Access Compliance Report Public Rights-of-Way (Curb Ramps)

Intersection ID: N/A Main Street: TUCKASEEGEE_RD Cross Street: N_I-85_RA Location: SE

ADA ID: 5C8A2BE3EBA0 Ramp Type: Directional1 Initial Pass/Fail: Fail Overall Compliance: No Severity Score: 37.5

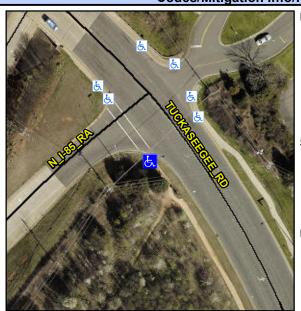
Possible Solution	
Possible Solutions:	Col
Remove & Replace Entire Ramp.	N/A
·	Yes
	No
	No
	N/A
	N/A
Surveyor Notes:	N/A
PONDING	N/A
	N/A
	N/A
	N/A
PROW/ADA:	N/A
R304.2.2, R304.5.3	N/A
	N/A
	N/A
	N/A

Field Measurements/Component Compliance						
Comp	liance Description	Data	Comp	liance Description	Data	
N/A	Ramp Length (in)	135.5	N/A	Grade Break?	N/A	
Yes	Ramp Width (in)	61.0	N/A	Grade Break Slope (%)	0.0	
No	Ramp Slope (%)	12.4	N/A	Grade Break XSlope (%)	0.0	
No	Ramp XSlope (%)	5.7				
N/A	Flare Type LT	N/A	N/A	Flare Type RT	N/A	
N/A	Flare Slope LT (%)	N/A	N/A	Flare Slope RT (%)	0.0	
N/A	Flare Traversable LT?	N/A	N/A	Flare Traversable RT?	N/A	
N/A	Landing Length (in)	0.0	N/A	DWS Provided?	N/A	
N/A	Landing Width (in)	0.0	N/A	DWS Contrast?	N/A	
N/A	Landing Slope (%)	0.0	N/A	DWS Length (in)	N/A	
N/A	Landing X Slope (%)	0.0	N/A	DWS Full Width?	N/A	
N/A	Landing Curb? (Y/N)	N/A	N/A	DWS Offset LT (in)	N/A	
N/A	Shared Landing?	N/A	N/A	DWS Offset RT (in)	N/A	
N/A	Gutter Ponding?	0.0	N/A	Gutter Slope (%)	N/A	
N/A	Gutter Lip Ht (in)	0.0	N/A	Gutter X Slope (%)	N/A	
N/A	Painted X Walk1?	Yes		Road Slope (%)	6.9	
	X Walk 1 Direction	To NW		Road X Slope (%)	5.9
